RE: Sundown Solar Farm, Inverell Shire (SSD 8911)

We have reviewed the documents supplied, with a focus on the Biodiversity Development Assessment Report (BDAR) prepared by EMM, dated June 2023 and completed a site inspection on 5 and 6 September 2023.

Attachment 1 – BCD Recommendations - Sundown Solar Farm – Biodiversity Development Assessment Report

Attachment 2 – Detailed BCD comments - Sundown Solar Farm – Biodiversity Development Assessment Report

Figure 1: Screenshot of project components map from BDAR with selected examples (circled red) of proposed solar array areas with no connection.

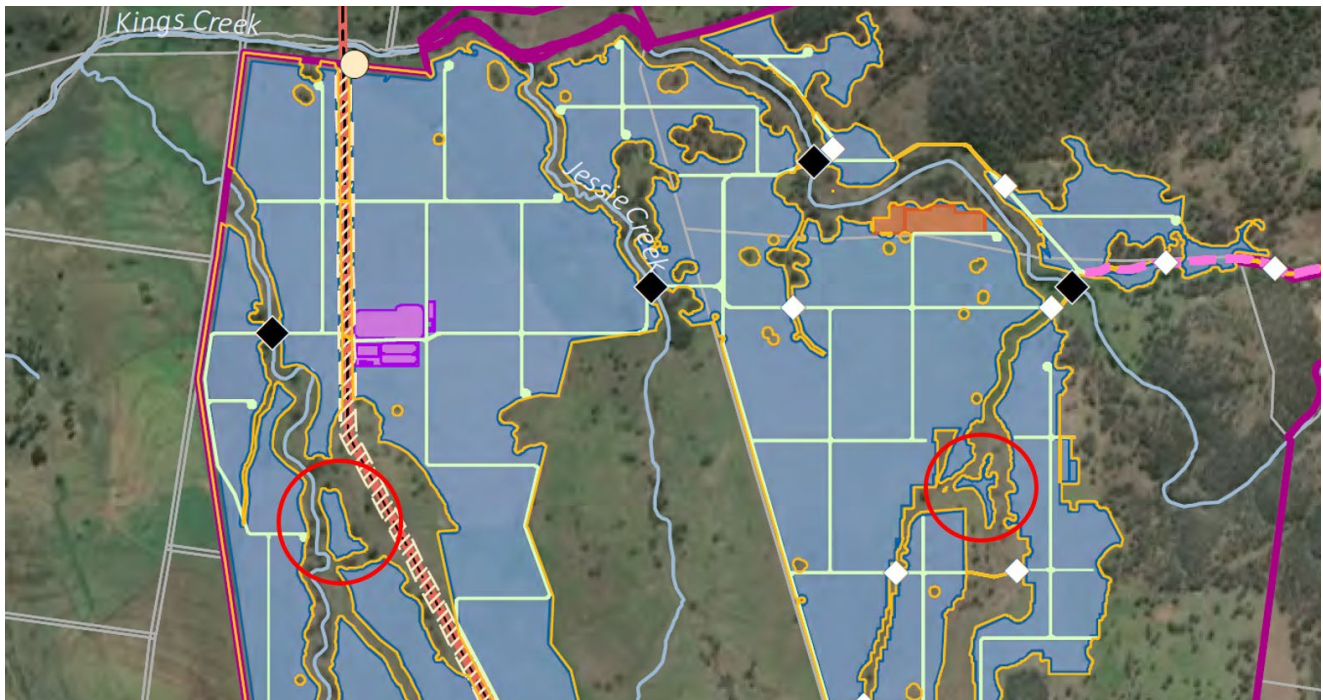
Several parts of the development footprint presented in the Biodiversity Development Assessment Report (BDAR) and Environmental Impact Statement (EIS) and identified as potential solar array areas are not connected to any other part of the footprint (**Figure 1**). To construct solar panels in these areas would require road and cable connections to other parts of the footprint. All development components that would result in loss of biodiversity values are to be included in the development footprint and calculated in the total direct impact of the project.

- 1.1 The proposed development footprint be revised to ensure all project areas and components are connected and include all connections in the assessment.
- 1.2 The proposed development footprint be revised to limit the creation of small, unviable 'islands' of retained habitat.
2. The proposal requires revision to further avoid and minimise impacts to SAIL Box Gum Woodland and to include additional and appropriate measures to minimise impacts on the SAIL entity

Figure 2: Screenshot of project components map from BDAR with selected examples (circled red) of small, isolated avoided areas unlikely to provide viable habitat in the long term.

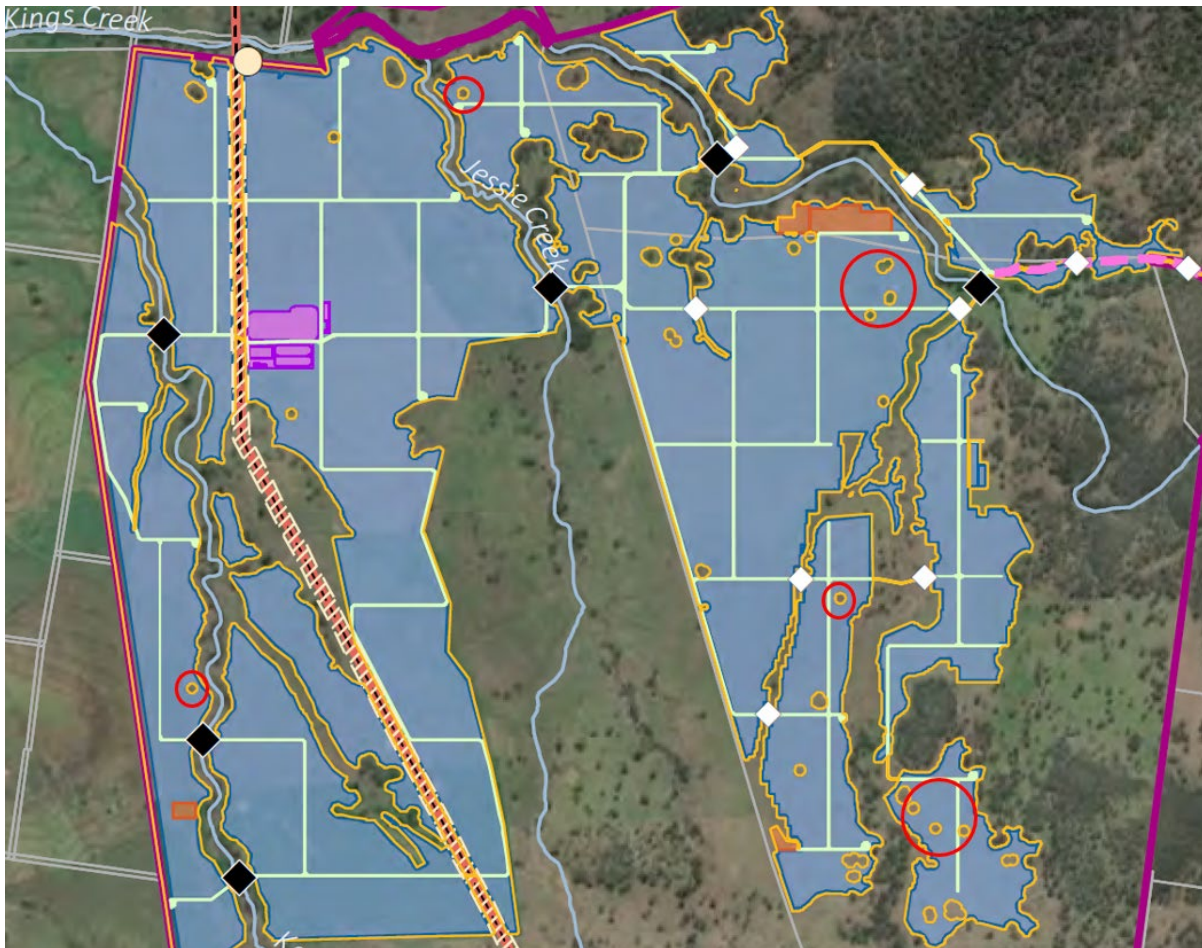
The development footprint includes numerous small 'cut-outs' where isolated records of threatened flora species were identified and are proposed to be avoided (**Figure 2**). The BCD acknowledges this represents an effort to avoid and minimise impacts on threatened flora species. However, given their small area and proposed isolated locations surrounded by solar arrays and other infrastructure, we consider these retained areas are unlikely to provide viable habitat in the long-term. Therefore, unless the protection, management and long-term viability of these areas can be demonstrated, they should be included within the development footprint. We understand some other small areas proposed to be avoided have been excluded from the footprint to protect heritage values, however if biodiversity values are likely to be impacted these areas should be assessed as a loss in the BDAR.

Figure 3: Some examples of indicative areas where opportunities exist to further avoid and minimise impacts to SAIL Box Gum Woodland CEEC are shown in red. Yellow line indicates approximate location of an existing cleared track that should be used to minimise impacts to intact woodland.

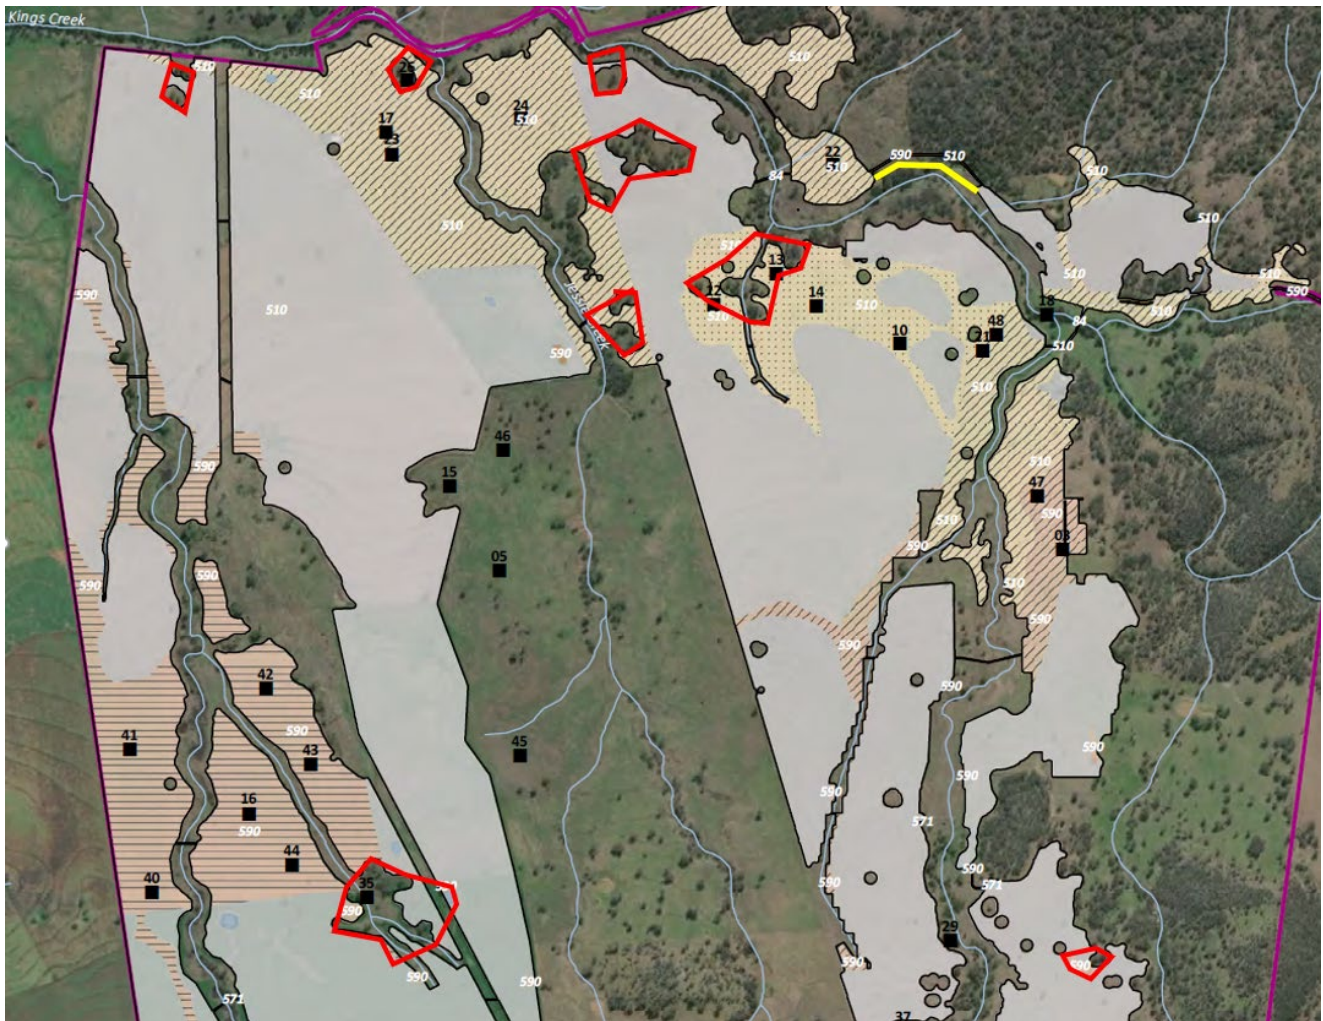
However, based on our review of the BDAR and field observations, we have identified other potential opportunities to further avoid impacts on the SAIL entity (**Figure 3**), which include:

- revising the development footprint to further avoid woodland areas and better connect avoided areas.
- regularising boundaries between avoided areas and the development footprint to reduce the perimeter, hence reducing edge effects and improving viability of avoided areas.
- modifying the location of a proposed internal access road to align with an existing track instead of traversing intact woodland.

- 2.1 The consent authority notes the proposal is likely to have a Serious and Irreversible Impact on the Box Gum Woodland CEEC.
- 2.2 The proposed development footprint be revised to further avoid and minimise impacts to woodland areas of the Box Gum Woodland CEEC.
- 2.3 The BDAR be revised to include additional and appropriate measures to minimise impacts on the Box Gum Woodland CEEC such as revegetation to improve connectivity between avoided areas and within riparian corridors.

Figure 4: Locations of woodland patches currently mapped within DNG areas that require remapping and should be avoided.

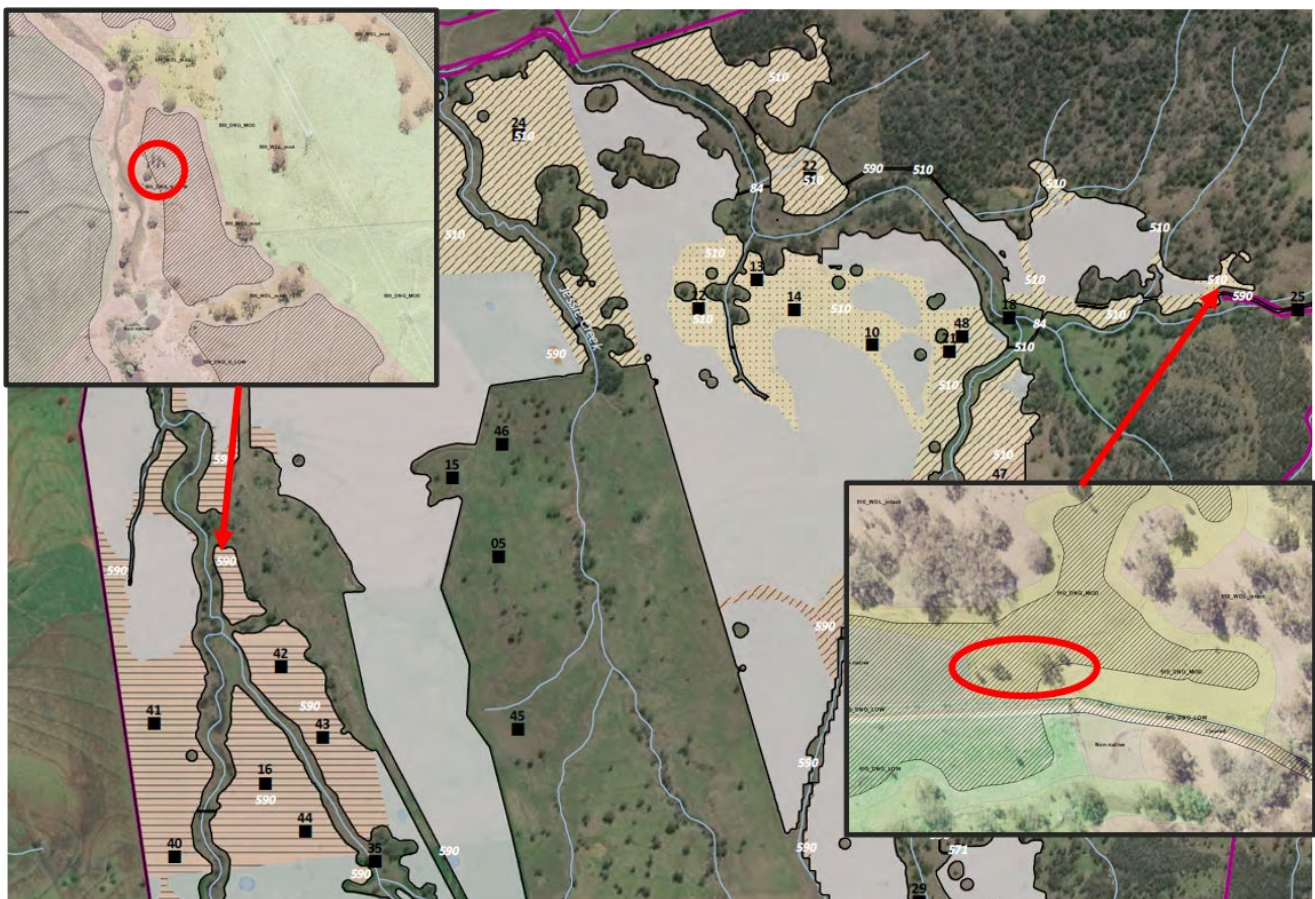
During the site inspection, BCD officers also identified two small woodland patches occurring within mapped DNG zones, which had not been allocated to an appropriate woodland zone (**Figure 4**). Revision of the mapping is required to accurately map these areas, which should be avoided.

- 3.1 The assessor revises the vegetation mapping to address scattered trees within DNG areas, and ensure all woodland areas are included in the appropriate vegetation zone.
- 3.2 Update Table 4.2 of the BDAR to include a new condition class for scattered trees in DNG areas that are not otherwise mapped as woodland, and a description of the DNG “very low” class.

Figure 5: Extract from figure 5.4 of BDAR showing targeted flora survey effort with red circles added to indicate examples of unsurveyed suitable habitat for candidate threatened flora species.

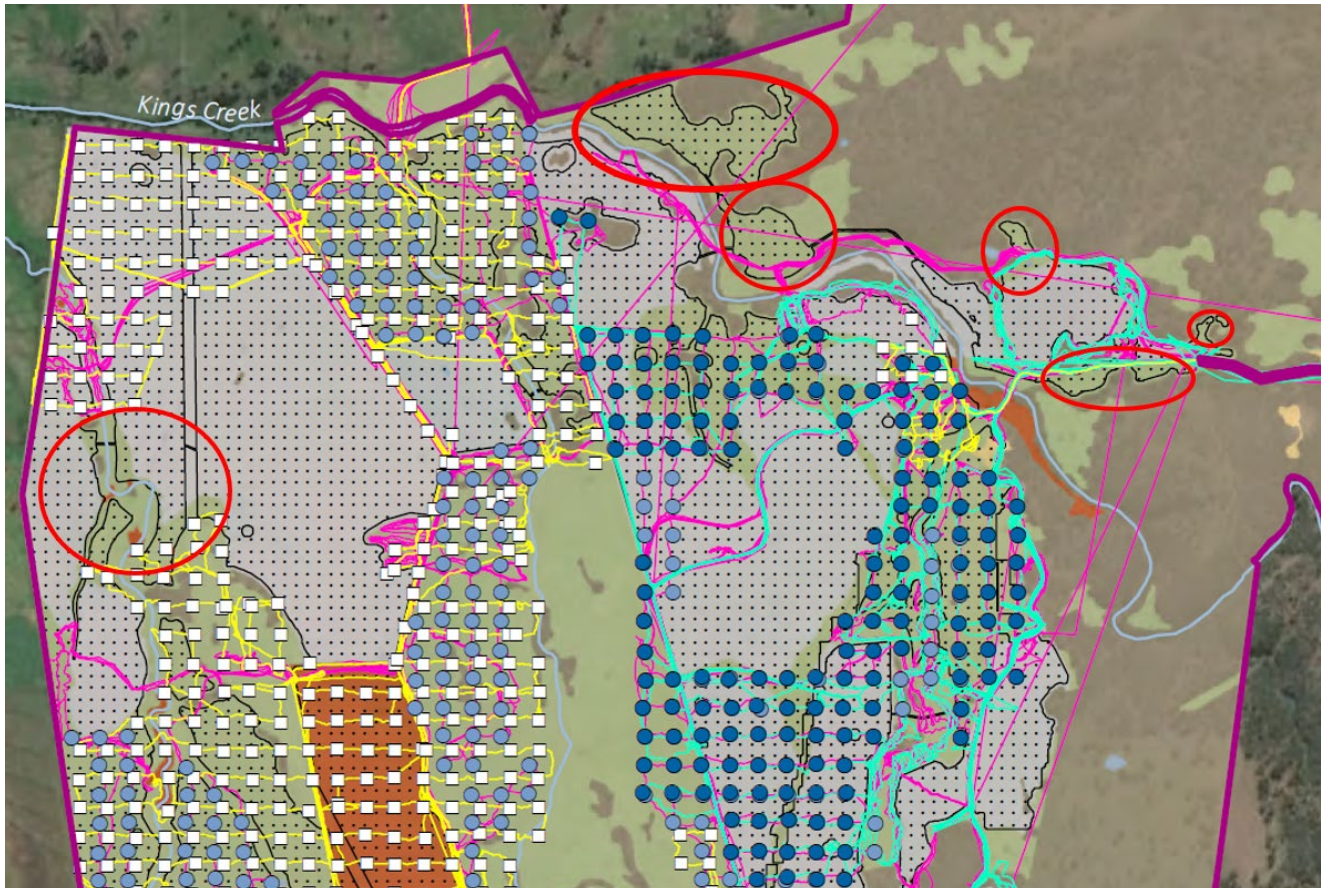
Targeted threatened flora survey effort is presented in Figure 5.4 of the BDAR. Several areas of derived native grassland within the development footprint appear to have no survey. These areas represent suitable habitat for several candidate species, including Bluegrass and Austral Toadflax, which have been recorded in the same vegetation zones on the site. The assessor must determine whether each candidate species is present across all areas of suitable habitat in accordance with Section 5.2.4 of the BAM.

- 4.1 Revise the BDAR to determine presence of candidate threatened flora species in all areas of suitable habitat either by undertaking targeted survey¹, assuming presence or by obtaining an expert report.
- 4.2 Review the species polygons for Bluegrass and Austral Toadflax after addressing recommendation 4.1.
